Access Compliance Report

Public Rights-of-Way

Intersection ID: 42504	Main Street: ALEXANDER MARTIN AV	Cross Street: TOLLESON AV	Location: E
ADA ID: 7546FCAB4F55	Ramp Type: PerpDiag	Initial Pass/Fail: Fail	Overall Compliance: No
Codes/Mitigation Info/Possible Solution		Field Measurements/Component Compliance

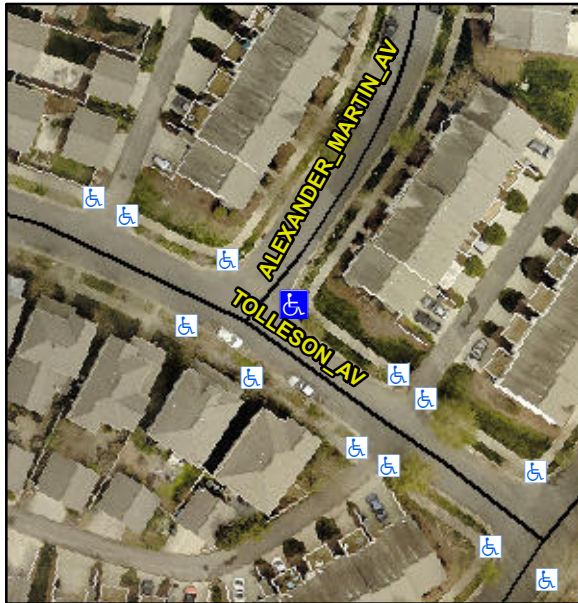
Not Found, R304.2.2, R304.5.3

Compliance	Description	Data	Compliance	Description	Data
N/A	Ramp Length (in)	62.5	No	Ramp Slope (%)	12.3
Yes	Ramp Width (in)	49.5	No	Ramp XSlope (%)	2.1
N/A	Flare Type LT	N/A	N/A	Flare Type RT	N/A
N/A	Flare Slope LT (%)	N/A	N/A	Flare Slope RT (%)	N/A
N/A	Flare Traversable LT?	N/A	N/A	Flare Traversable RT?	N/A
N/A	Landing Length (in)	N/A	N/A	DWS Provided?	N/A
N/A	Landing Width (in)	N/A	N/A	DWS Contrast?	N/A
N/A	Landing Slope (%)	N/A	N/A	DWS Length (in)	N/A
N/A	Landing X Slope (%)	N/A	N/A	DWS Full Width?	N/A
N/A	Landing Curb? (Y/N)	N/A	N/A	DWS Offset (in)	N/A
N/A	Shared Landing?	N/A			
N/A	Gutter Ponding?	N/A	N/A	Gutter Slope (%)	N/A
N/A	Gutter Lip Ht (in)	N/A	N/A	Gutter X Slope (%)	N/A
N/A	Painted X Walk1?	No	N/A	Painted X Walk2?	No
	X Walk 1 Direction	To NW		X Walk 2 Direction	To SW
N/A	X Walk 1 Width (in)	N/A	N/A	X Walk 2 Width (in)	N/A
	X Walk 1 Slope (%)	1.7		X Walk 2 Slope (%)	3.5
	X Walk 1 X Slope (%)	1.8		X Walk 2 X Slope (%)	1.3

Remove & Replace Curb Ramp With Two New Directional Ramps or Equivalent.
